H. B. ROBINSON UNIT NO. 2  
LICENSE DPR-23  
SAFETY INJECTION PUMP PERFORMANCE

In response to your request of November 28, 1973, Carolina Power & Light Company submits Operating Plant Change No. 1 to the H. B. Robinson FSAR. Incorporated in this proposed change to the FSAR are minimum performance characteristics for the safety injection pumps and the supporting safety analyses for the small break loss-of-coolant accident (LOCA).

FINAL SAFETY ANALYSIS REPORT  
OPERATING PLANT CHANGE NO. 1

Figure 6.2-7

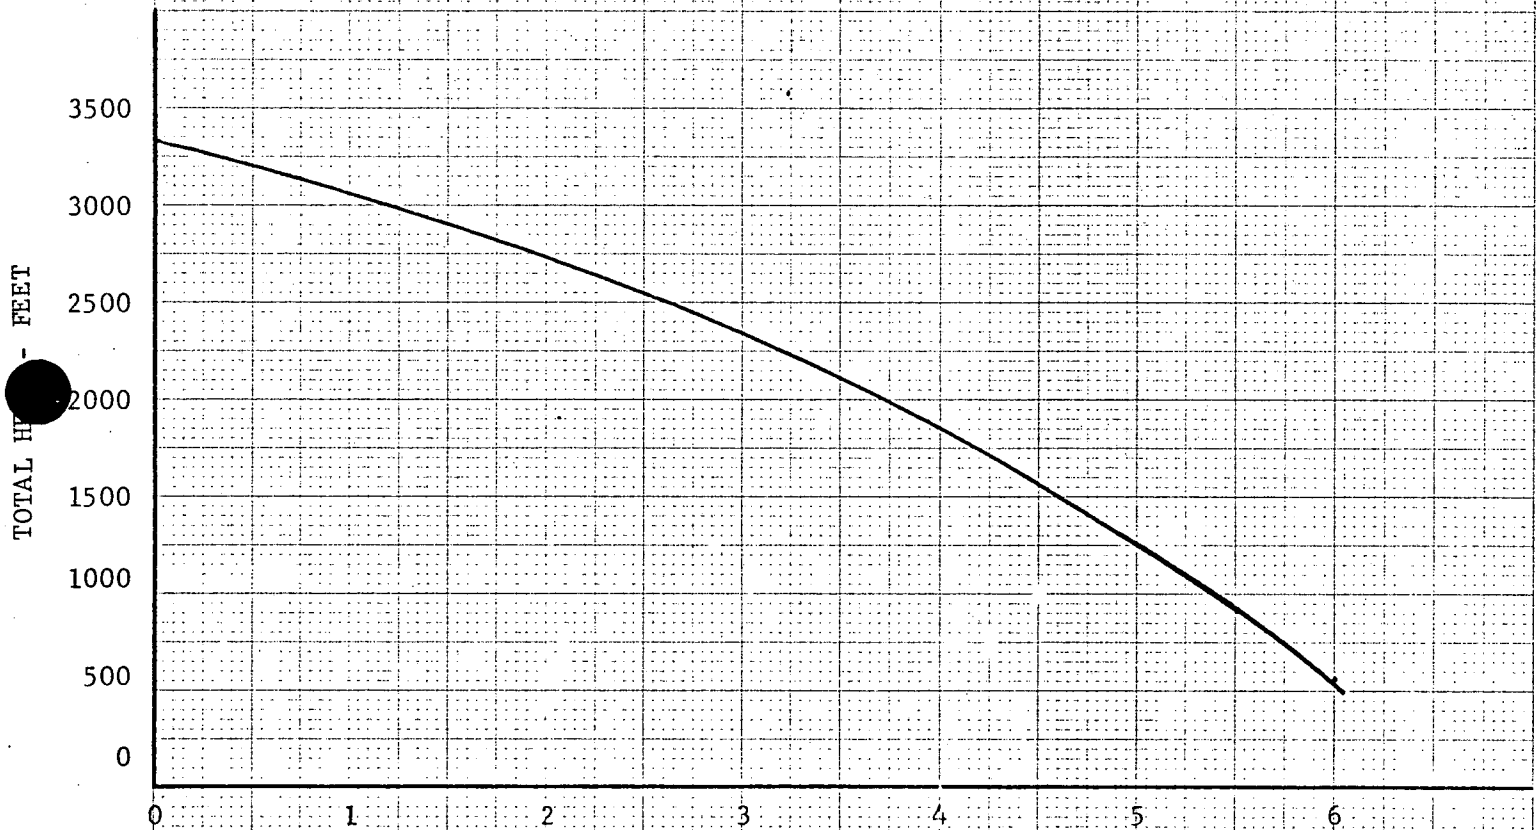
The performance characteristic in Figure 6.2-7 reflects the measured performance of the pumps as determined during the Cycle 1 - Cycle 2 refueling outage. The measured pump performance in combination with the measured system resistance results in a system delivery rate that is conservative with respect to those used in the steam break and the small break LOCA safety analyses, which are shown in Figure 14.3.2-17.

Figure 14.3.2-17

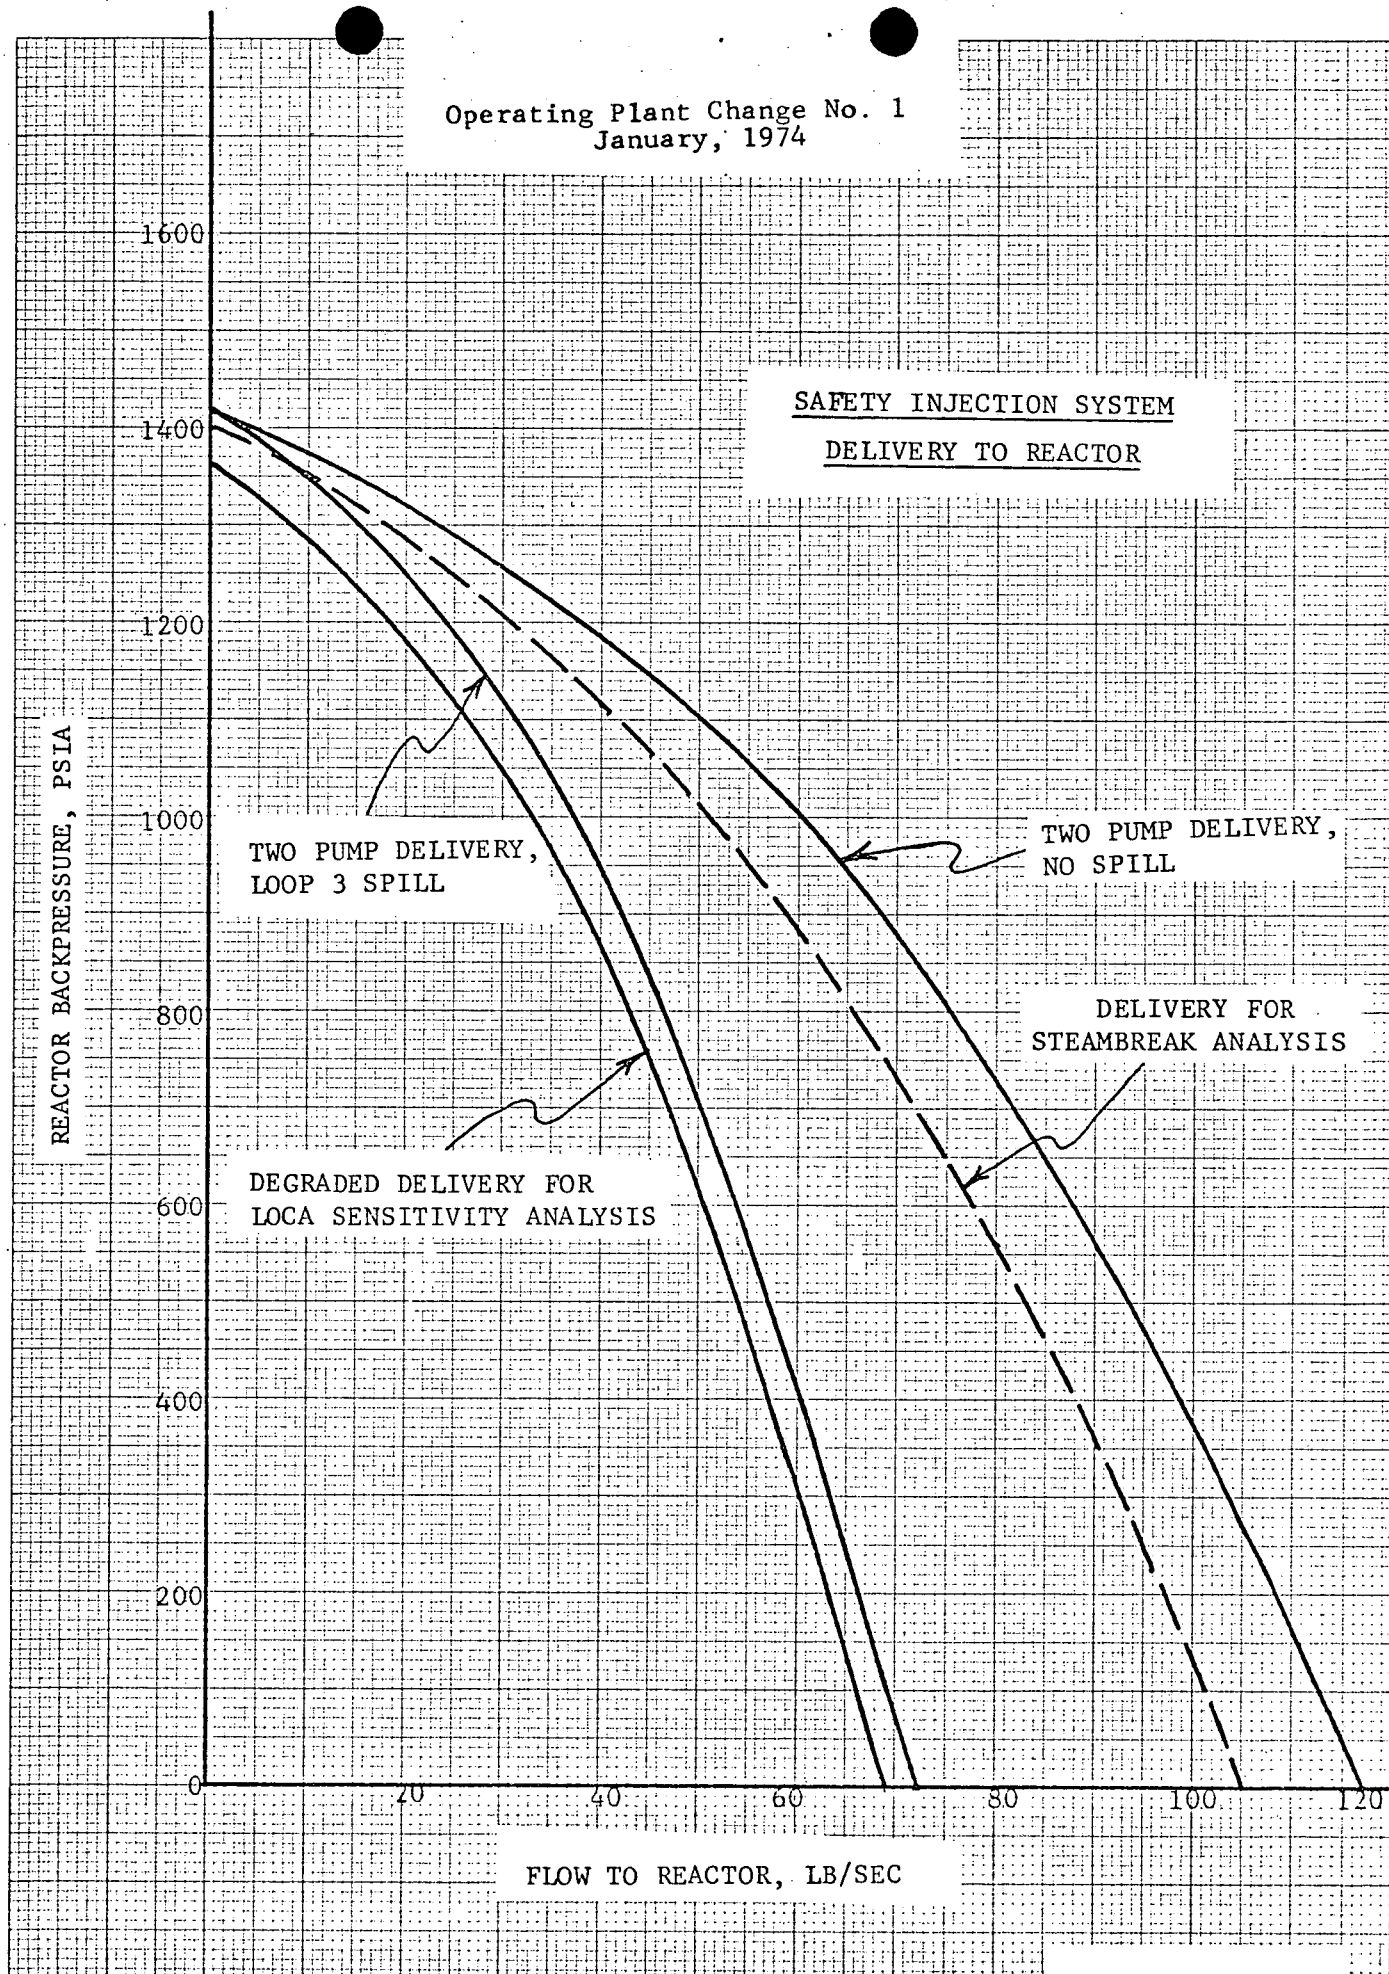
1.30 would be experienced. In the analysis presented in WCAP-8243, for 2300 MWt operation, the same delivery rate was assumed. The delivery curve used in previous analyses of the steam break accident and the curve referred to above are incorporated in revised Figure 14.3.2-17 in the attachment and will be referenced in the uprating amendment.

Safety injection pump and system performance was again measured and reported in May, 1973<sup>(23)</sup>. The measured performance was the same as used in the small break analysis for reactor backpressure less than 900 PSIG. At higher backpressures, the measured performance was somewhat better than that used in the analysis. In order to access the effect of possible pump wear, the system performance was arbitrarily degraded by reducing both extremes on the pump performance curve (1) shutoff pressure and 2) runout flow by 5% each and constructing a curve of similar shape (to the original curve) through those points. The resulting curve (Figure 14.3.2-17) shows a reduction of approximately 10% in "Flow to Reactor" at 1000 PSIG backpressure.

CPL Small Break LOCA Analyses Pressure History  
Min. Safety Injection

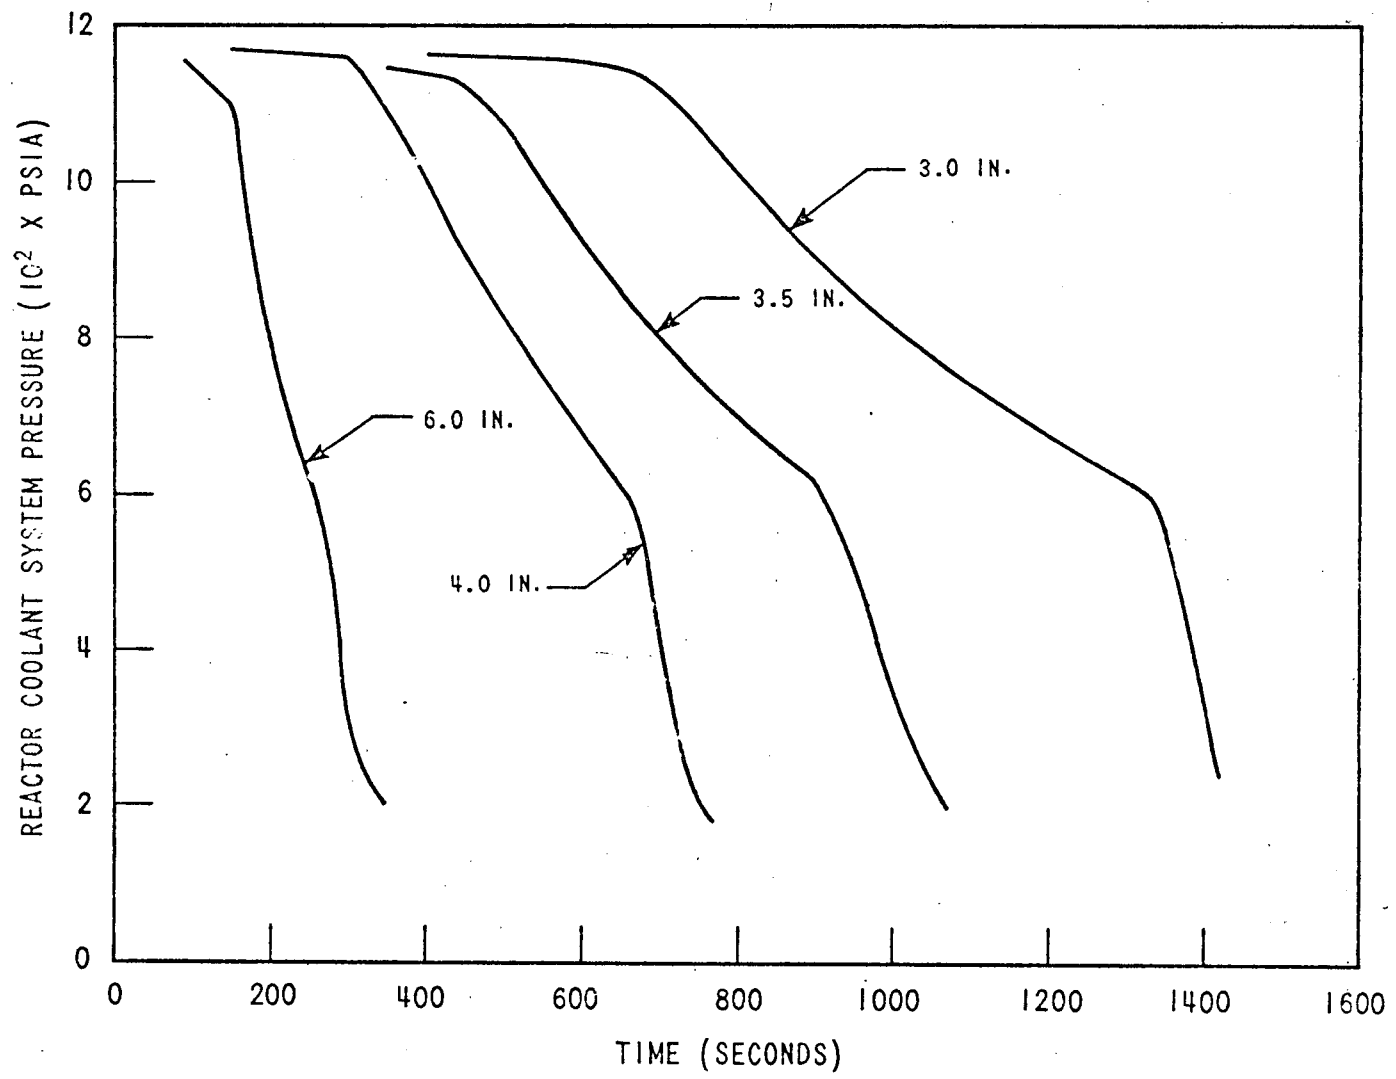
The Reactor Coolant System pressure and volume for the range of break sizes are presented in Figure 14.3.2-18 and Figures 14.3.2-22 through 14.3.2-25, respectively. The volume figures illustrate both quiet and froth levels.
